Proposed Development at Hollingworth Road and Rakewood Road, Littleborough

DESIGN RESPONSE DOCUMENT

The following Design Response Document (DRD) has been produced as a comprehensive response to issues raised following the submission of a planning application comprising residential development and a new primary school at land off Hollingworth Road and the reconfiguration of and extension to the existing car park off Rakewood Road. The hybrid planning application was validated by Rochdale Borough Council in July 2024, and assigned reference: 24/00581/HYBR.

Summary of layout changes presented by Bloor at Jan 2025 meeting

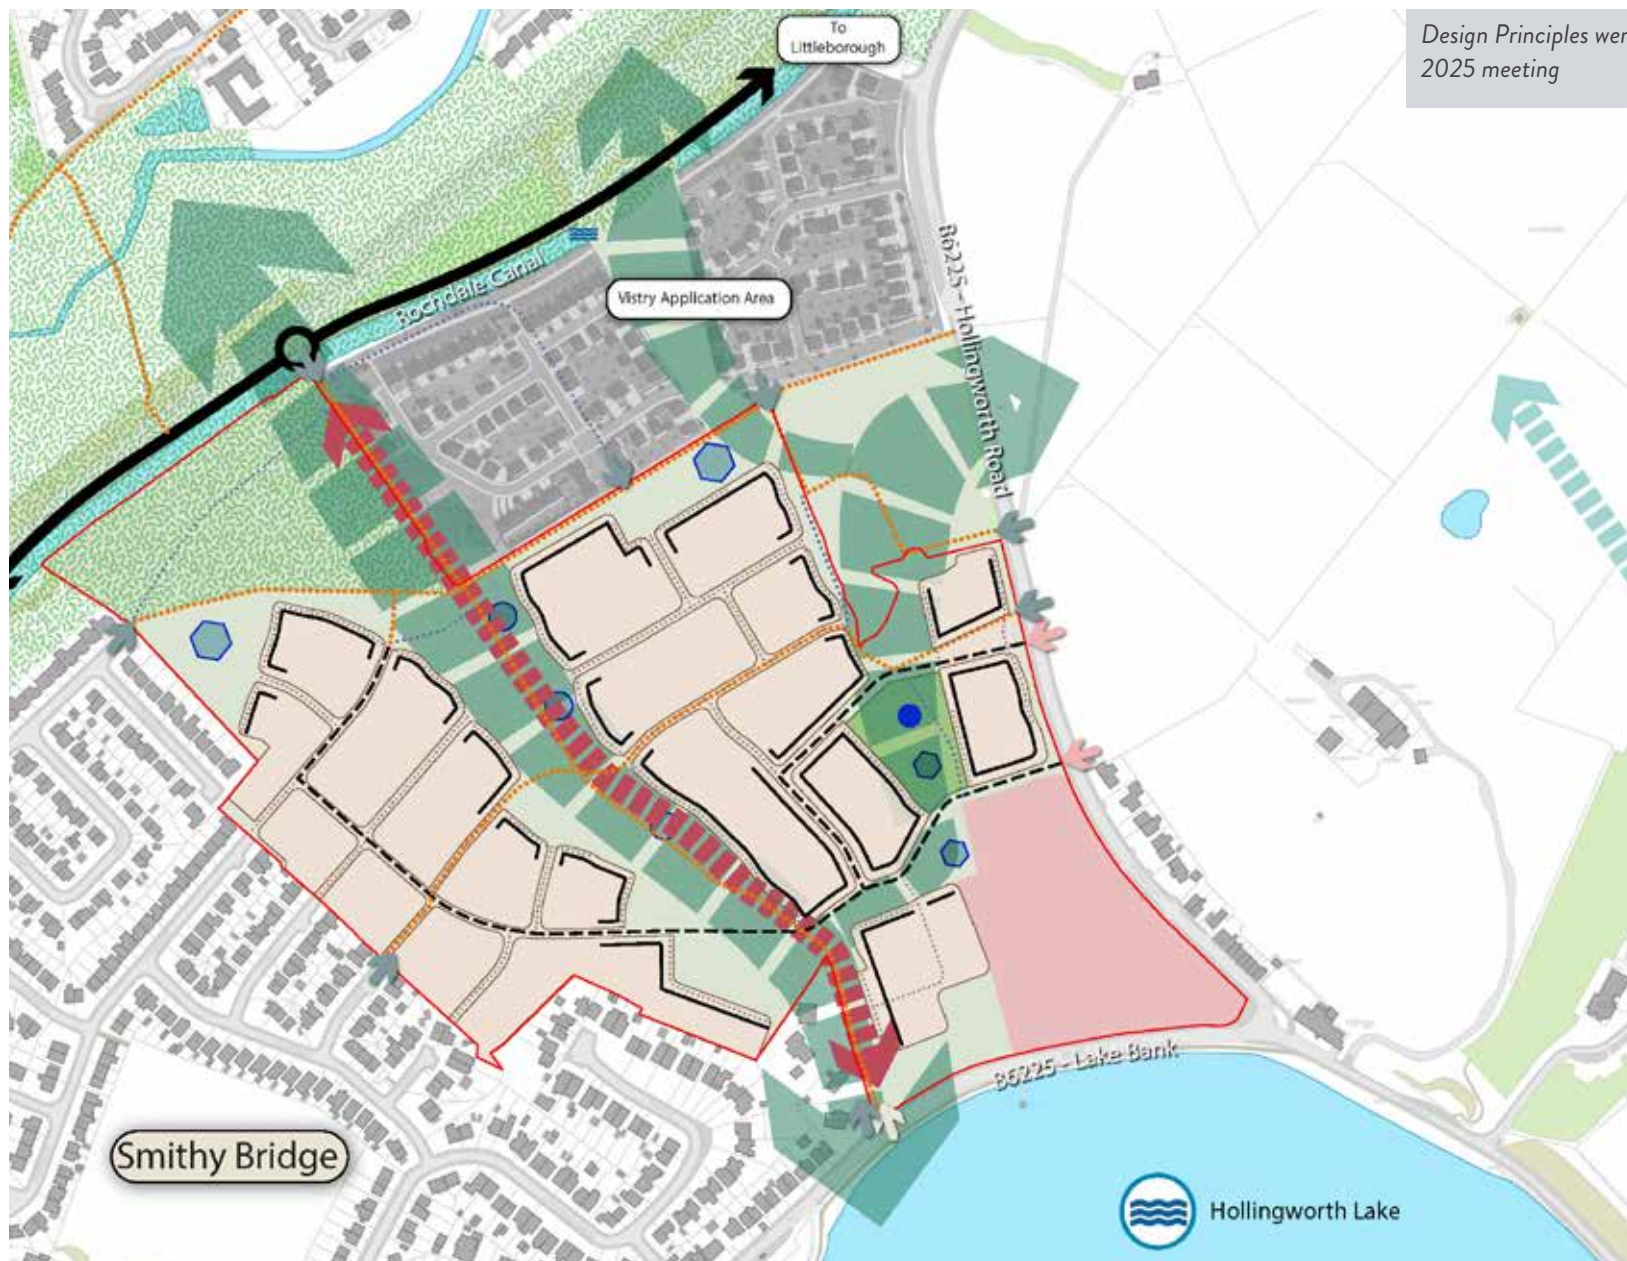
- Generally agreed with the overall design principles which underpin the scheme
- Agreed with access roads removed from prominent site frontages
- Officers queried whether a vehicular access to the Smithy Bridge estate to the west should be included. Applicant re-iterated that strong advice by officers previously not to include vehicular access into the Smithy Bridge estate, due to the steepness and narrowness of the streets.

- Highways request to widen the north-south footway/ cycle way through the central parkland to a minimum of 4m. It was generally agreed that this in conflict with the DRP view to maintain 'wildness' in that area.

- Housetypes to be simplified
- 3D visuals needed to help officers and members understand key areas
- Potential for green verge to be included adjacent to Hollingworth Road

- Officer preference to retain heritage features, but if that is not possible there is a need for justification.
- The character of the existing farm buildings should be reflected in the scheme.

- Clarity needed on character areas and frontage treatments especially Hollingworth Road. Officers see this currently as one 'character area'.
- The layout along the eastern edge of the main open space needs to ensure buildings are facing and overlooking the public open space.

Left - Extract of layout and revised character area

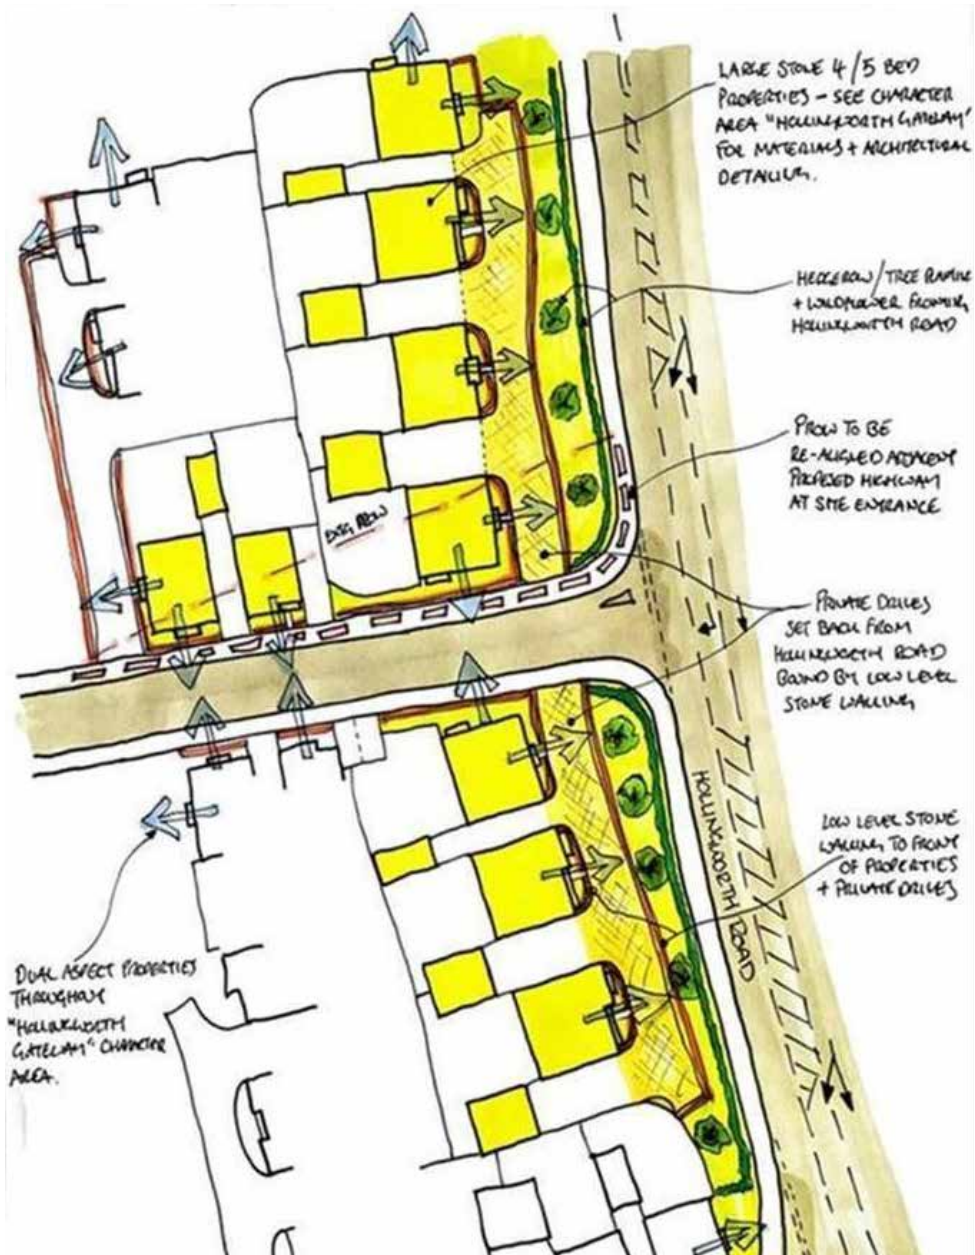
- Housetypes in this area facing out over the open space need to be more distinctive and respond to local character more - due to elevation these will likely be prominent in views from Hollingworth Road and wider. As proposed the Hill View Secondary units are rather standard. Could include balconies/terraces overlooking open area / towards hills to make better use of the outlook.

- On this frontage a different building type might respond better to the rural character of this stretch of Hollingworth Road - potentially terraces, rather than semis which are more suburban in character. Terraces might require parking court. This unit oddly placed, rotated

- Geometry to be adjusted, possibly move site access north
- Still needs work to understand character and how this area will feel. Consider whether dry stone walls could enclose the road. Maybe low stone wall on one side and hedging/low trees the other. This would make it feel more comfortable and less exposed.

- Variety of housetypes is too great in Hollingworth Gateway Primary and Secondary for a relatively small area.
- Seems like an odd arrangement - private driveways across footpaths. Should be double-fronted or rotated units on the corner

Having reviewed the extent of this character area the parcel to the East directly adjacent to Hollingworth Road is now entirely within the same character area which has also been extended to include the properties along the primary avenue into the development as indicated by the blue shading on the extract opposite.

These house types will be unique in design both elevationally and regarding the amenity space landscaping. Summarised revised proposals below:

- Properties constructed with Beckstone
- Slate Grey roof tiles
- Chimneys to selected plots (as indicated via the blue dot on the extract opposite)
- All grey windows and doors
- Black fascia and barge
- 2 course stone window cill and headers
- 150mm stone detail around door
- Low level stone walls to front gardens with planting behind (max height 600mm)

Furthermore, the frontage to Hollingworth Road has been re-designed to achieve the following:

- Variety of house types reduced
- 2.5 Storey properties replaced with larger 4/5 bed properties with parking located behind the building line
- Terraces avoided due to parking required via rear parking courts and existing sewer easement restricting the ability to front out the open space behind if this parking were to be included
- PROW alignment re-configured (requires diversion) to align with proposed access road. This eliminates the skewed plot orientation and crossing point over the private drive.
- Entrance landscaping re-designed to include a combination of low-level stone walling to the private drive, tree planting and hedgerow planting
- Dual aspect properties included throughout the character area on all corner plots
